Proposed Milton Quarry East Extension JART COMMENT SUMMARY TABLE – Natural Environment

JART Comments (December 2022)	Reference	Source of Comment	Applicant Response	JART Response
Report/Date: Level 1 and 2 Natural Environment Technical Report (NETR) and Environmental Impact Assessment (EIA) December 2021 Author: GHD

FIGURE 1 Wetland U1 and Wetland V2 in relation to the extraction limit boundary

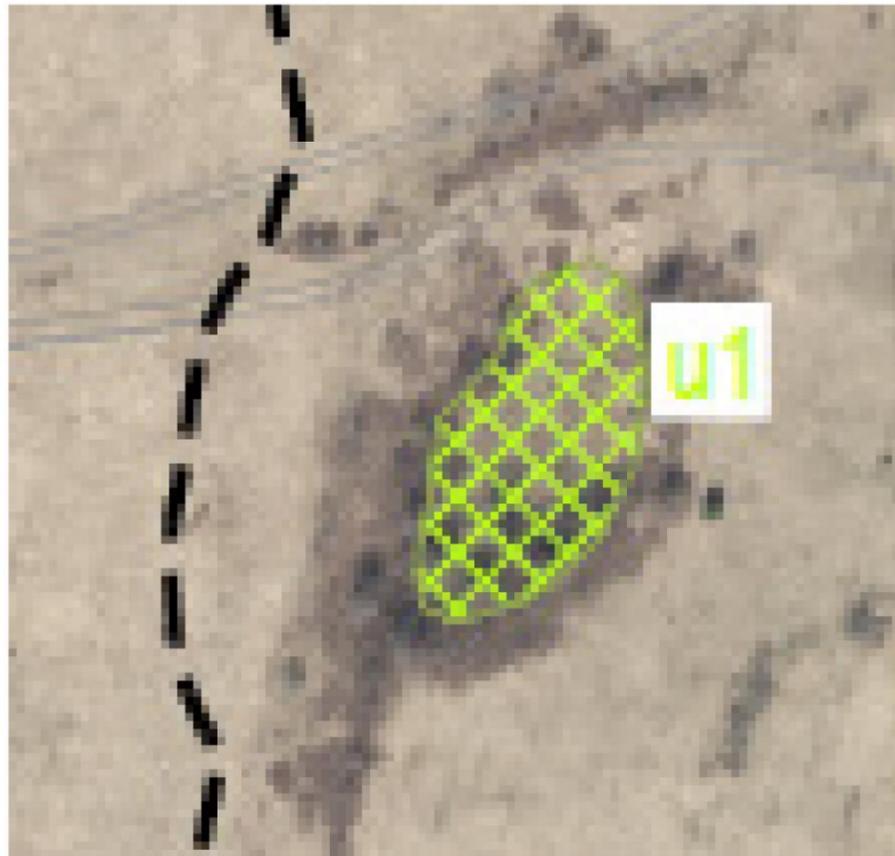
34.	The Level 1 and 2 NETR and EIA (Goodban 2021b) identified a confirmed Jefferson Salamander and Unisexual Ambystoma breeding pond contained within the licensed area of the MQEE named as wetland U1. The NETR also identified another confirmed Jefferson Salamander and Unisexual Ambystoma breeding pond breeding pond, known as wetland V2, that occurs just outside of the licensed area boundary to the north and northeast of the proposed extraction area limit.	General	Matrix Solutions

<p>(Figure 36 of the Level 1 and 2 NETR)</p> <p>Figure 40 of the Level 1 and 2 NETR shows that the distance from the edge of the MQEE extraction limit and wetland U1 to be 50 m. For wetland V2, no distance measurement is provided between the edge of the MQEE extraction limit and the wetland boundary in any of the figures provided in in the Level 1 and 2 NETR. However, based on the scale of the mapping provided in the NETR, the distance from the northeast corner edge of the MQEE Extraction Limit to wetland V2 is estimated to be 60 to 70 m. The northern edge of wetland V2 appears to be within 35m of the southern extraction limit of the East Cell. It is not known whether blasting will occur or has already occurred within the northern edge of wetland V2, as this is within an existing approved licensed area in the East Cell. The Level 1 and 2 NETR states that expansion of the quarry will occur with the elimination of the common setback between the East Cell and the MQEE.</p> <p>As blasting is used to break up the rock as part of the excavation process, it is assumed that blasting activities in the East Cell and the MQEE will be conducted near wetland V2 at distances ranging from 35 to 70m. It is also assumed that blasting activities will be conducted within 50 m of wetland U1.</p>
